Economic Commission for Europe**Inland Transport Committee****World Forum for Harmonization of Vehicle Regulations****Working Party on Brakes and Running Gear****Seventy-fifth session**

Geneva, 17-19 September 2013

Regulations Nos. 13 and 13-H (Braking) –**Braking symbols in Regulation No. 121 (Identification of controls, tell-tales and indicators)****Proposal for amendments to Regulation No. 13-H (Brakes of M₁ and N₁ vehicles)****Submitted by the expert from the United Kingdom***

"**Model A1**

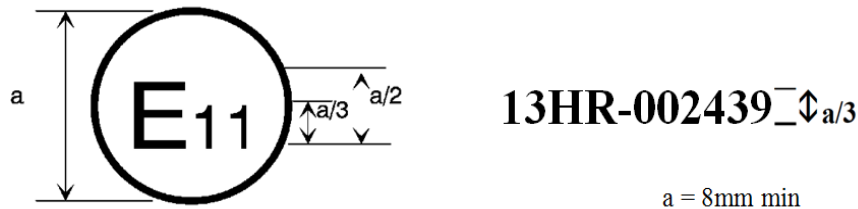
Model A1, amend to read:

The above approval mark affixed to a vehicle shows that the vehicle type concerned has, with regard to braking, been approved in the United Kingdom (E11) pursuant to Regulation No. 13-H under approval number 002439. The first two digits of the approval number indicate that the approval was granted in accordance with the requirements of Regulation No. 13-H in its original form."

"**Model A2**

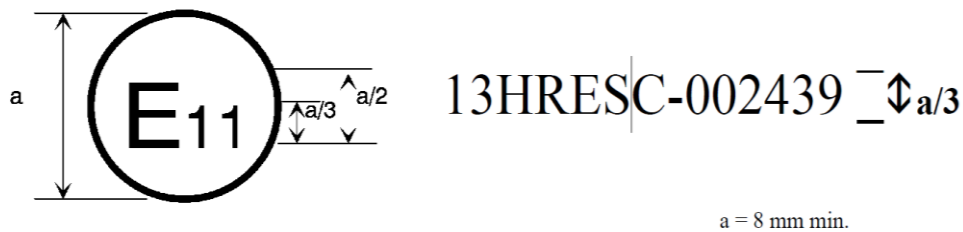
Model A2, amend to read:

The above approval mark affixed to a vehicle shows that the vehicle type concerned has, with regard to braking, been approved in the United Kingdom (E11) pursuant to Regulation No. 13-H under approval number 002439. The first two digits of the approval number indicate that the approval was granted in accordance with the requirements of Regulation No. 13-H in its original form. The additional marking "ESC" indicates that the vehicle meets the Electronic Stability Control and Brake Assist System requirements of Annex 9 to this Regulation."

"Model A3

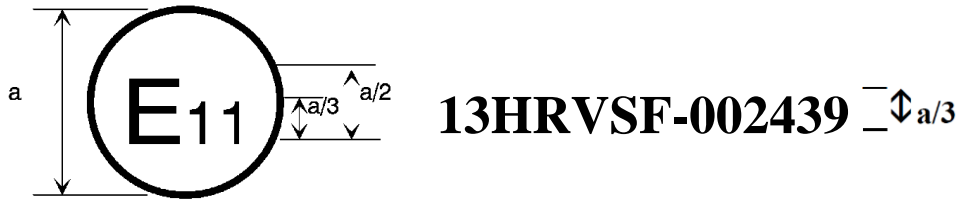
Model A3, amend to read:

The above approval mark affixed to a vehicle shows that the vehicle type concerned has, with regard to braking, been approved in the United Kingdom (E11) pursuant to UN Regulation No. 13-H under approval number 002439. The first two digits of the approval number indicate that the approval was granted in accordance with the requirements of UN Regulation No. 13-H in its original form. The additional marking "VSF" indicates that the vehicle meets the Vehicle Stability Function requirements of Annex 21 to UN Regulation No. 13 and Brake Assist System requirements of Annex 9 to this Regulation."
